APPLICATION NO.	FILING DATE	FIRST NAMED INVENTOR	ATTORNEY DOCKET NO.	CONFIRMATION NO.
10/576,054	04/18/2006	Naoya Tanaka	10921.399USWO	2150
52835	7590	05/28/2008	EXAMINER	
HAMRE, SCHUMANN, MUELLER & LARSON, P.C. P.O. BOX 2902 MINNEAPOLIS, MN 55402-0902			AYCHILLHUM, ANDARGIE M	
ART UNIT		PAPER NUMBER		
		2841		
MAIL DATE		DELIVERY MODE		
05/28/2008		PAPER

Office Action Summary	Application No. 10/576,054	Applicant(s) TANAKA, NAOYA
	Examiner ANDARGIE M. AYCHILLHUM	Art Unit 2841

DETAILED ACTION

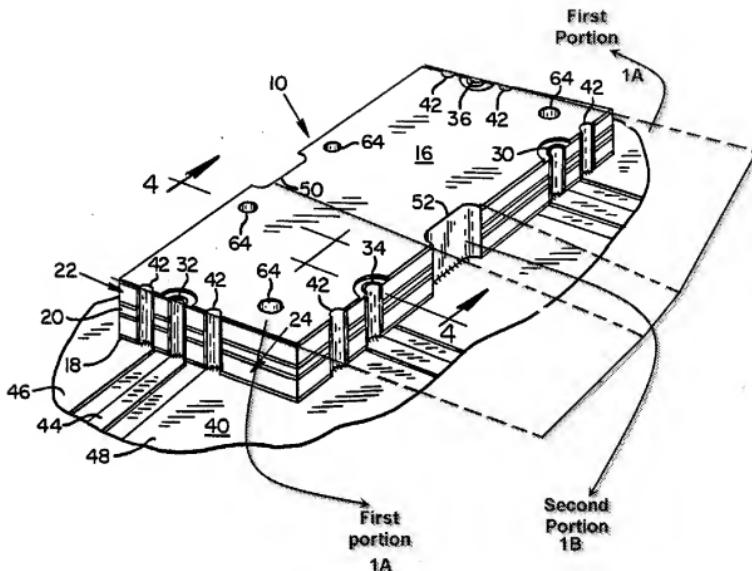
Pertaining to claim 1, Fields et al. discloses a wiring board (10) (see figs. 1-3) having a width (see figs. 1-3); and wherein the wiring board (10) comprises a first portion (1A, see below Fields et al. fig. 1) (the large portion) and a second portion (1B) (the small cross-section) (see below Fields et al. fig. 1), the first portion (1A) having a relatively large cross section (see figs. 1-3) extending across the wiring board (10) in a direction of the width (see figs. 1-3), the second portion (1B) having a relatively small

cross section extending across the wiring board (10) in the direction of the width, the first portion (1A) of the wiring board (10).

Fields et al. does not specifically disclose an electronic component.

However, Ziemkowski discloses an electronic component (103, 105, 107 and 109) (see Ziemkowski fig. 1) mounted on the first portion of the wiring board (100).

Therefore, it would be obvious to one having ordinary skill in the art at the time the invention was made to provide components mounted on the first portion of the wiring board (10) of Fields et al. device based on the teachings of Ziemkowski. The motivation being in order to provide circuit components on the wiring board that have different require functions, such as, signal amplification, and/or processing.

Pertaining to claim 2, Fields et al. discloses the wiring board (10) provided with a recess (below 52) (see figs. 1-3) for partially reducing the width of the wiring board (10).

Pertaining to claim 3, Fields et al. discloses the wiring board (10) is provided with a hole (30, 32, 34 and 36) (see figs. 1-3) penetrating the wiring board.

Pertaining to claim 4, Fields et al. discloses the wiring board (10) is provided with a groove (below 52) (see figs. 1-3) for partially reducing a thickness of the wiring board (10).

Pertaining to claim 5, Fields et al. as modified by Ziemkowski discloses the groove (below 52) is formed in a surface of the wiring board (10) that is opposite to another surface upon which the electronic component (101 of Ziemkowski) is mounted.

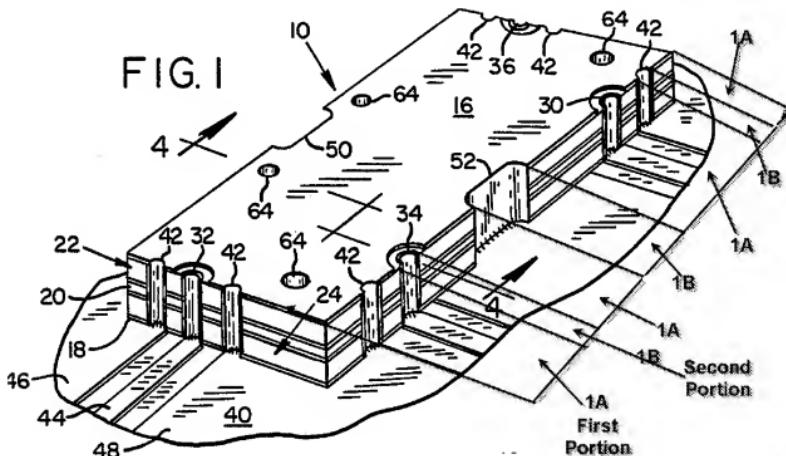
Pertaining to claim 6, Fields et al. as modified by Ziemkowski discloses the wiring board (10) having a width (see Fields et al. fig. 1 below) includes two first portions (1A) and a second portion (1B), each first portion (1A) having a relatively large cross section (see fig. 1 below) extending across the wiring board (10) in a direction of the width (see figs. 1-3), the second portion (1B) (see Fields fig. 1 below) intervening between the two first portions (1A) (see Fields fig. 1 below) and having a relatively small cross section extending across (see figs. 1-3) the wiring board (10).

Fields does not specifically disclose plurality of electronic components mounted on different portions of the wiring board.

However, Ziemkowski discloses plurality of electronic components (103, 105, 107 and 109) (see Ziemkowski fig. 1 below) mounted on different sections/portions of the wiring board (100).

Therefore, it would be obvious to one having ordinary skill in the art at the time the invention was made to provide electronic components on different sections/portions

of the wiring board (10) of Fields et al. device based on the teachings of Ziemkowski.

The motivation being in order to provide plurality of circuit components mounted on different sections of the wiring board for instance to arrange similar circuits on the same portions of the wiring board in order to simplify the wiring of the circuits that have different require functions.
